2.0. Responses to Written Comments

B. TOPICAL RESPONSES

Topical Response 1: Supplemental EIR

**Table 2.0-1
Project Impacts and Mitigation Ledger—Entrada South Planning Area**

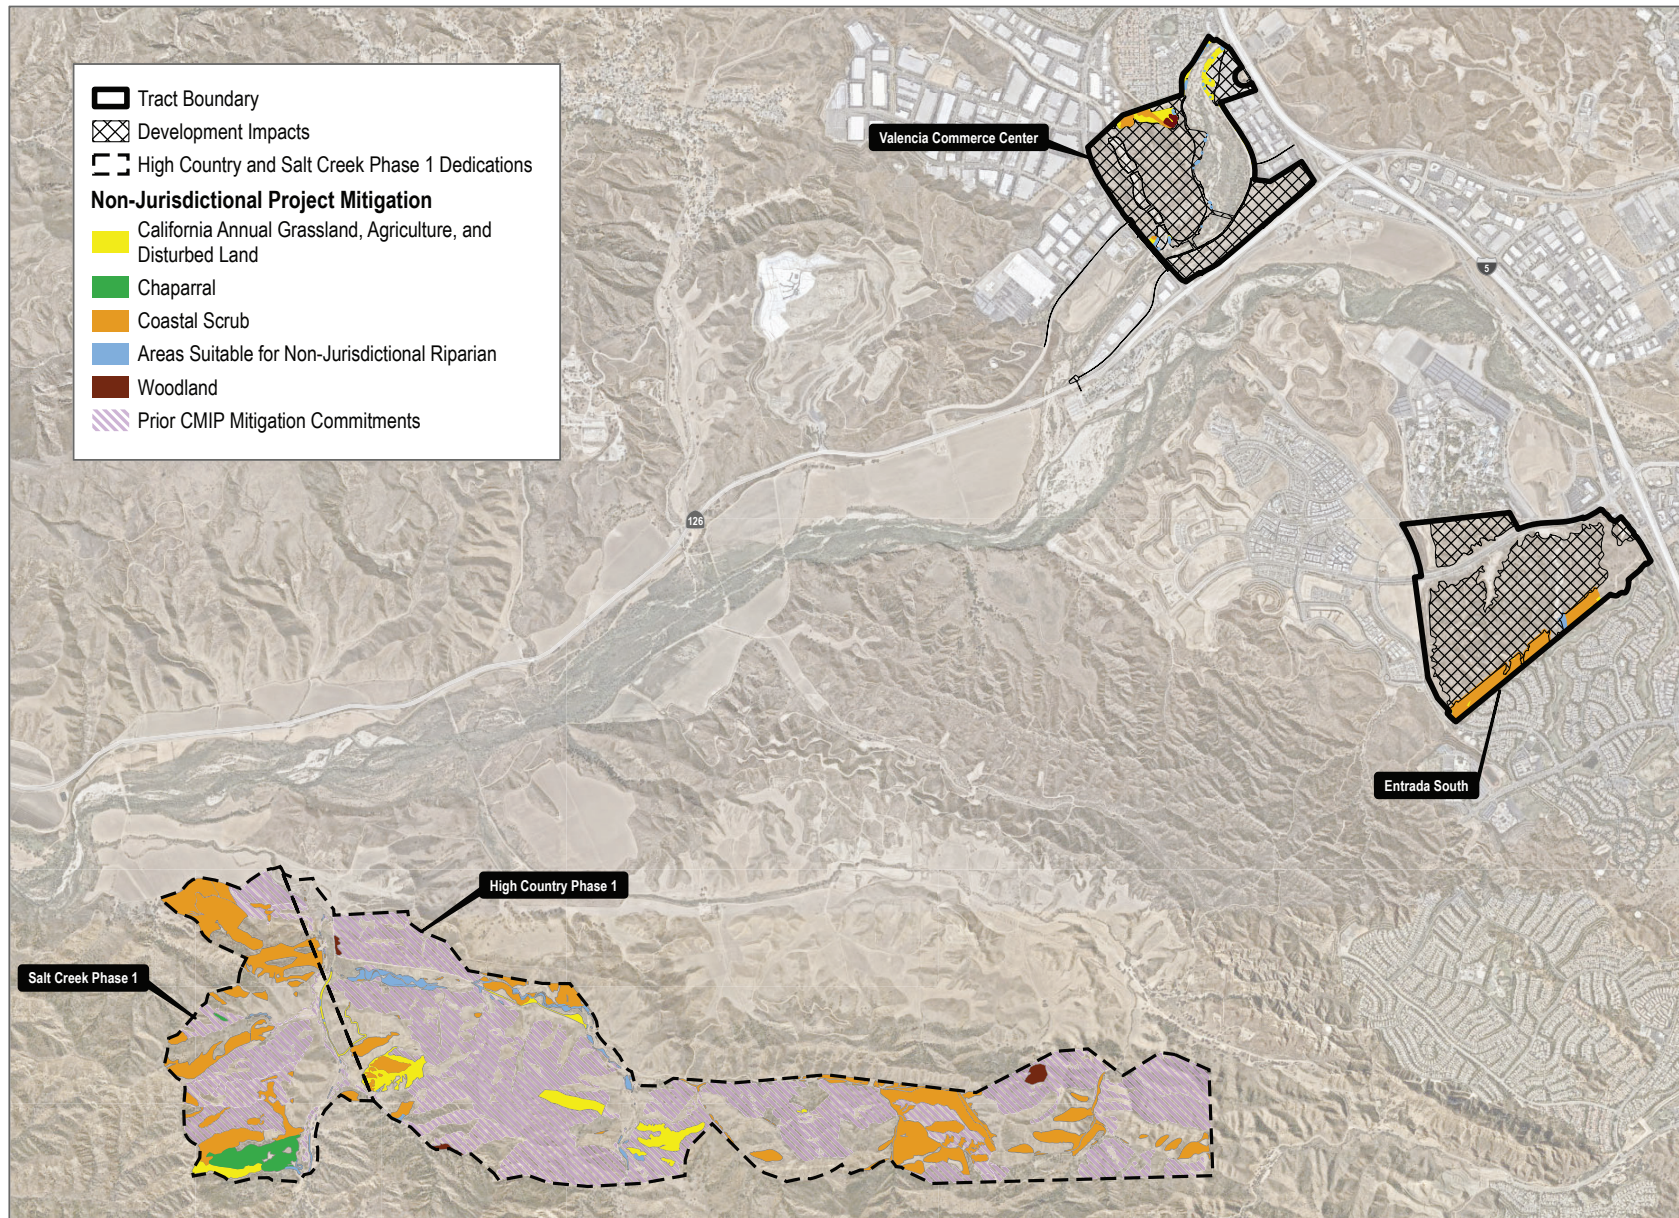
Recommendation #3: Mitigation Ledger Verification. To properly document 316.4 acres of permanent impacts associated with at Entrada South and 189.8 acres of permanent impacts at Valencia Commerce Center, CDFW requests the Project proponent provide a ledger or some appropriate accounting measure documenting the mitigation acreage debit from High Country, Salt Creek, and River Corridor conservation areas prior to Project activities.

The comment requests that the Project Applicant provide ledger verification documentation of the acreage of areas within the High Country, Salt Creek and River Corridor conservation areas that will be used to offset Project permanent impacts to habitat or vegetation communities. The requested accounting information is provided below and will also be included in the Comprehensive Mitigation Implementation Plan (CMIP) required by Mitigation Measures RMDP/SCP-BIO-1 and RMDP/SCP-BIO-20. **Figure 2.0-1, Project Mitigation Accounting of Locations as Identified in CMIP**, on page 2.0-30, shows the locations within the High Country and Salt Creek conservation areas that will be used to provide mitigation for Project impacts. In addition, **Table 2.0-1, Project Impacts and Mitigation Ledger—Entrada South Planning Area**, and **Table 2.0-2, Project Impacts and Mitigation Ledger—VCC Planning Area**, on page 2.0-31 summarize the acreages of those areas, as well as the corresponding acreages of Project impacts for the Entrada South Planning Area and VCC Planning Area, respectively. This summary does not change the conclusion in the Draft SEIR that the Modified Project would not cause any new or substantially more severe impacts to biological resources, as compared to the 2017 Project analyzed in the State-certified EIR.

The Project mitigation within the Newhall Ranch RMDP High Country and Salt Creek conservation areas occupies a total of 312.5 acres, in addition to a total of 38.5 acres located within the Entrada South and VCC Planning Areas, as summarized below.
